A D D E N D U M

Project Title: Carleton – Sewell Parking Garage	Addendum No: 5
Tender No: 2010-081209T	Date: December 8, 2010

ARCHITECTURAL AND STRUCTURAL ADDENDUM NO. 2

Date Issued: December 7, 2010
Issued By: Scott Wallace, P.Eng. (RJC)
Colin Turner, AANB (ADI)

Dwg. Title
**DETAIL - INTERIOR GLAZED
PARTITION**

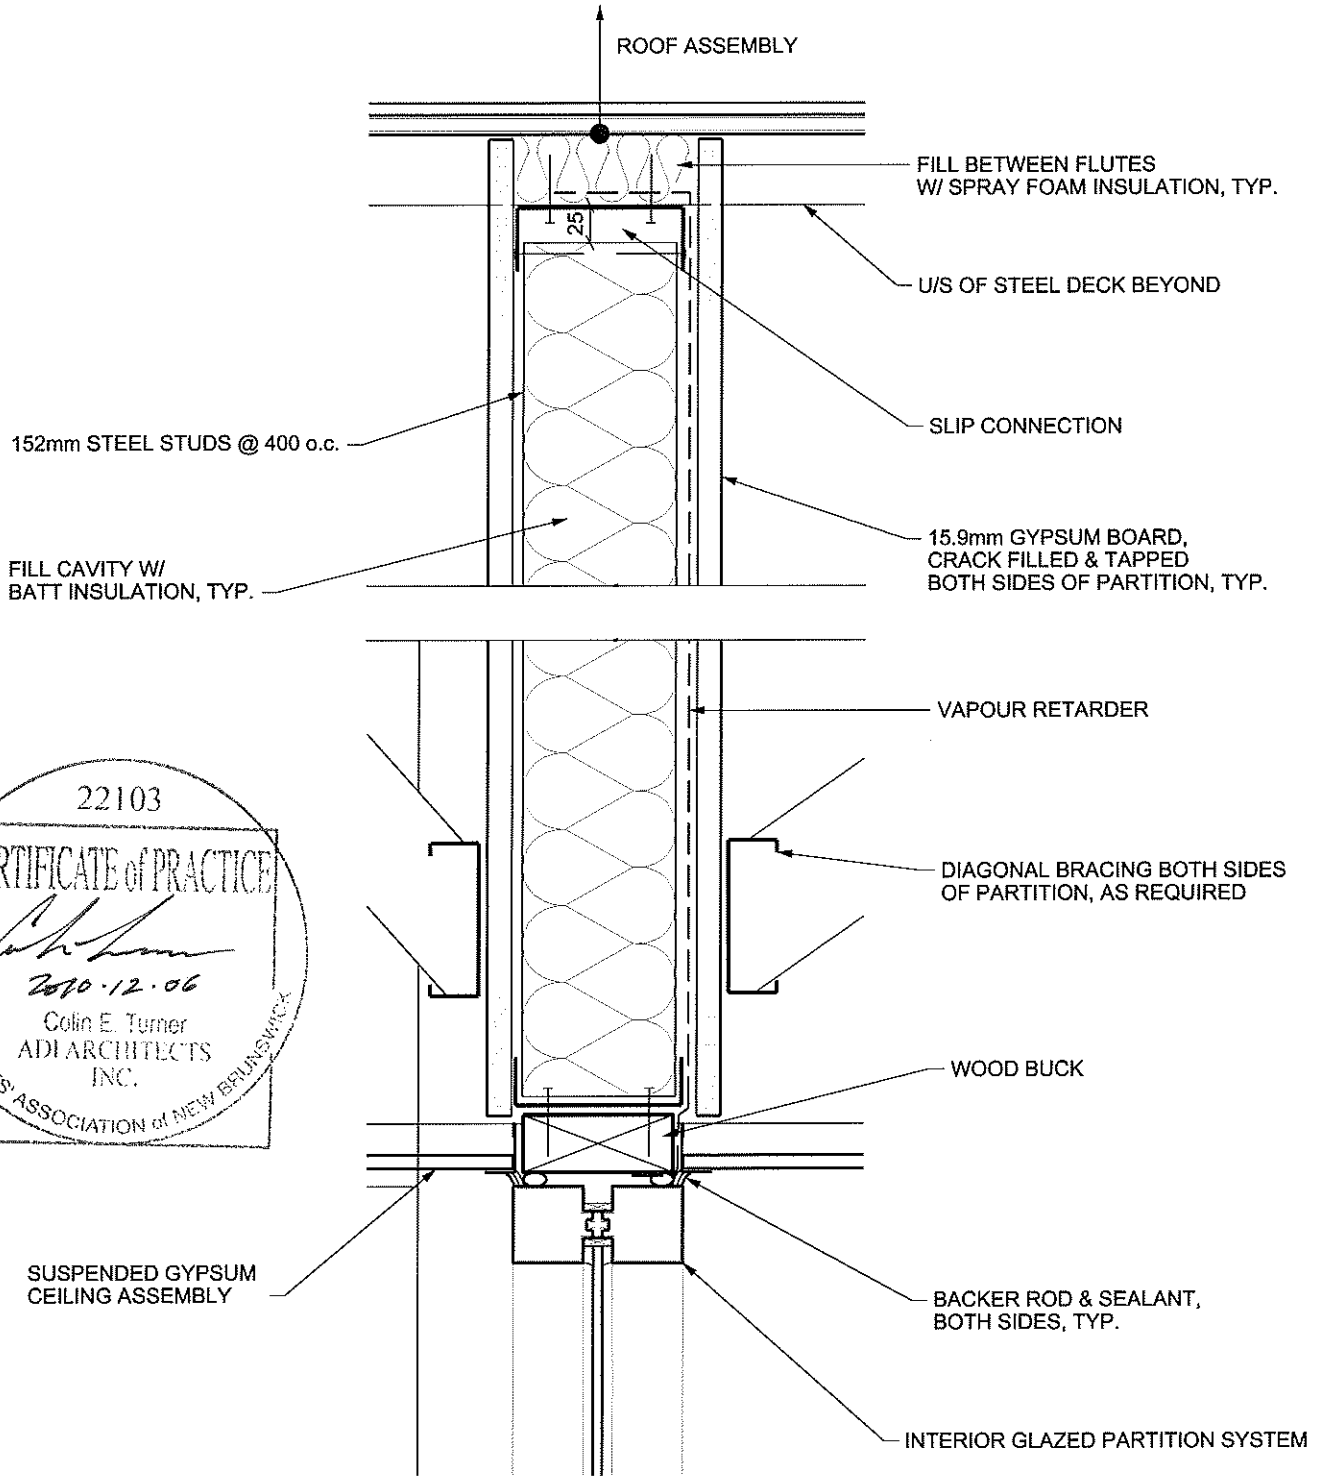
- .1 Provide structural metal framing in accordance with new Section 05410 attached.
- .2 Provide "fire seal base flashing" at all roof associated exposed wood in accordance with Section 07520.
- .3 Details 2/A404, 3/A404: insulate around penetrations through roof deck and around roof drains with "sprayed insulation" in accordance with Section 07219.
- .4 Detail 4/A404: provide as per new Drawing A404SK-01 attached.
- .5 Detail 5/A404: provide as per new Drawing A404SK-02 attached.
- .6 Detail 8/A404: provide as per new Drawing A404SK-03 attached.

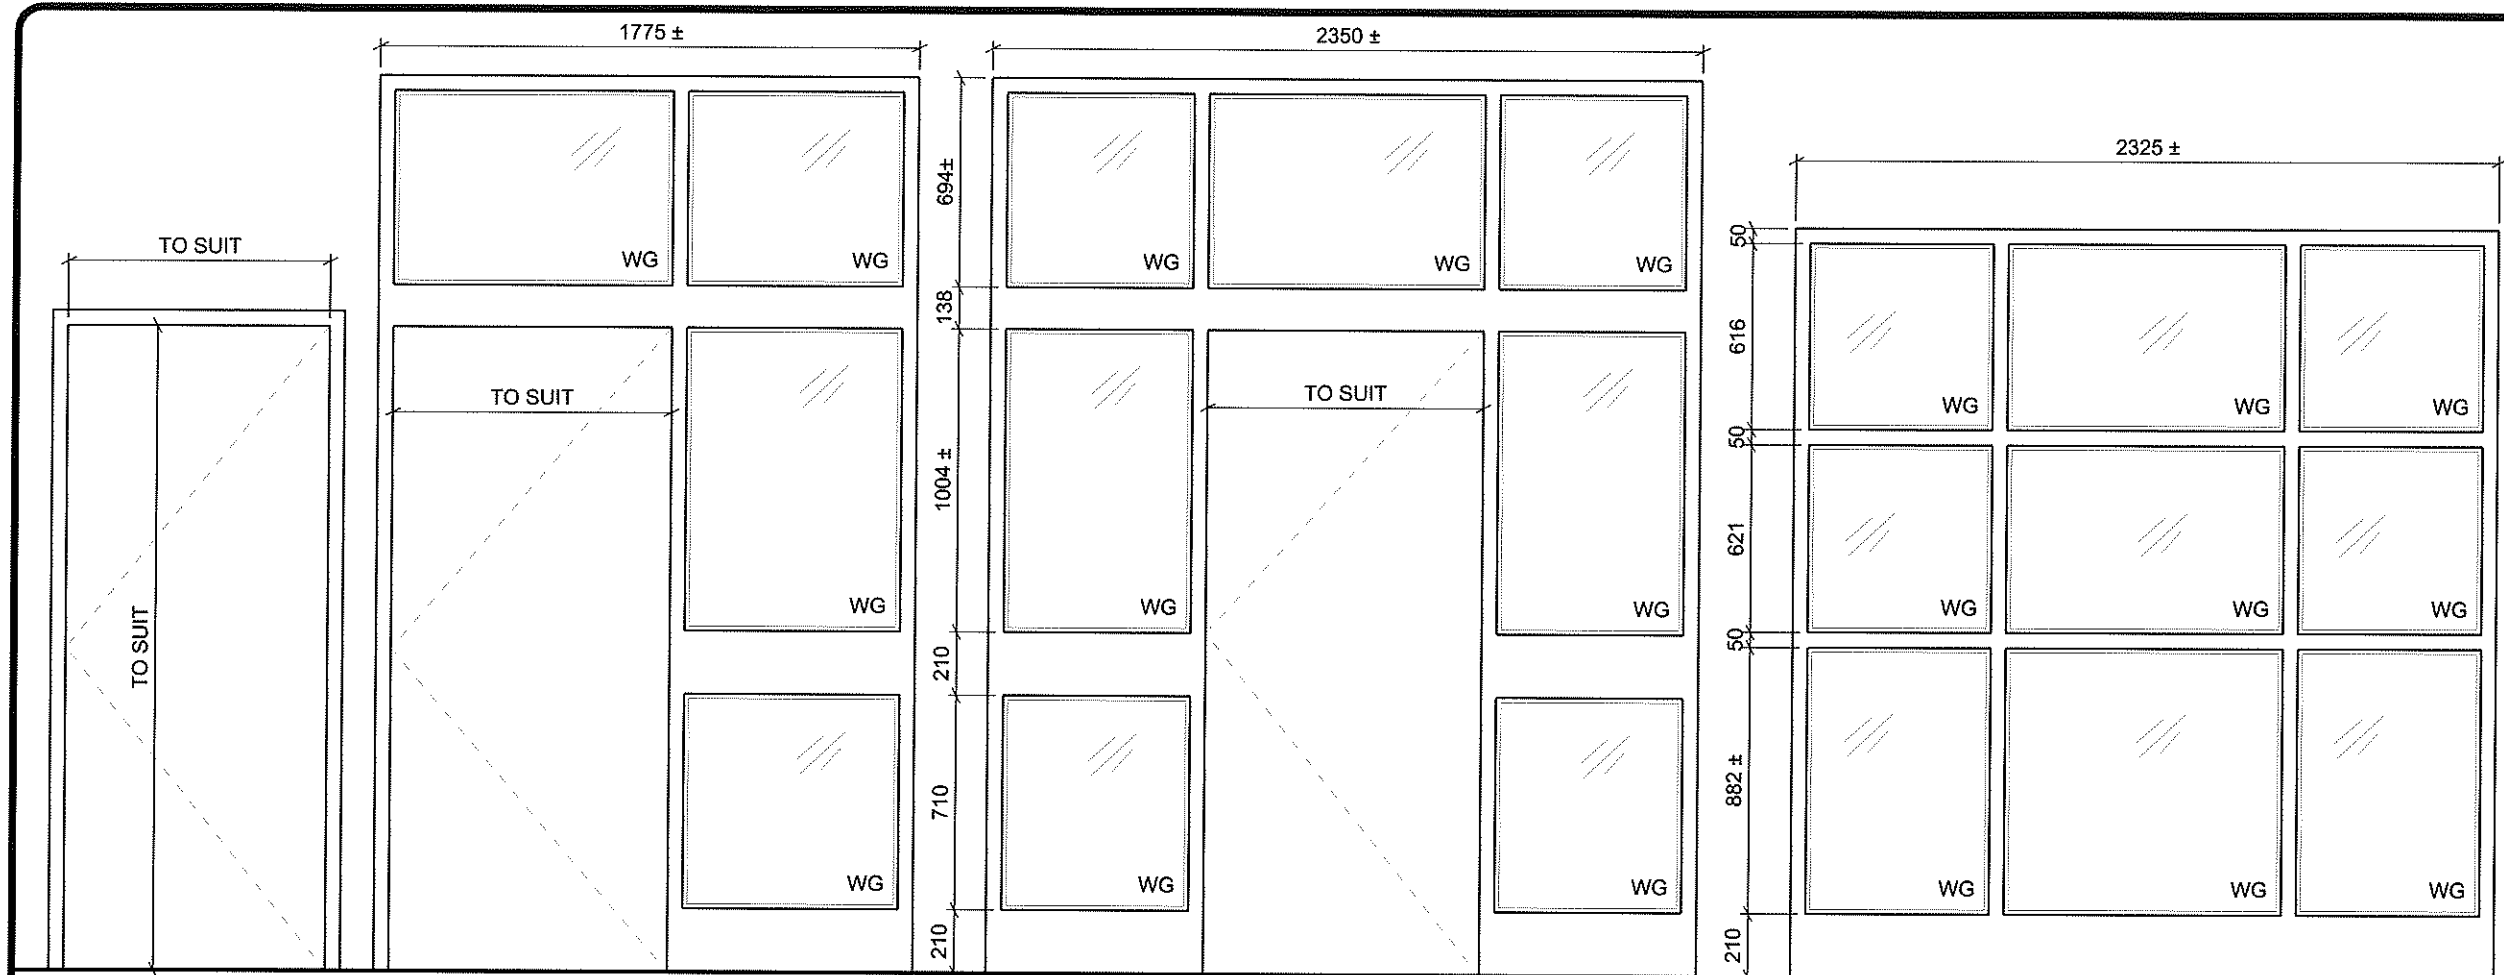
- .1 Door & Frame Elevations: provide as per new Drawing A601SK-01.
- .2 Room Finish Schedule: provide as per new Drawing A601SK-02.
- .3 Provide Hollow metal door and frame at P1 level exhaust shaft same as Parking/Mech. Elec. room doors indicated on door schedule.
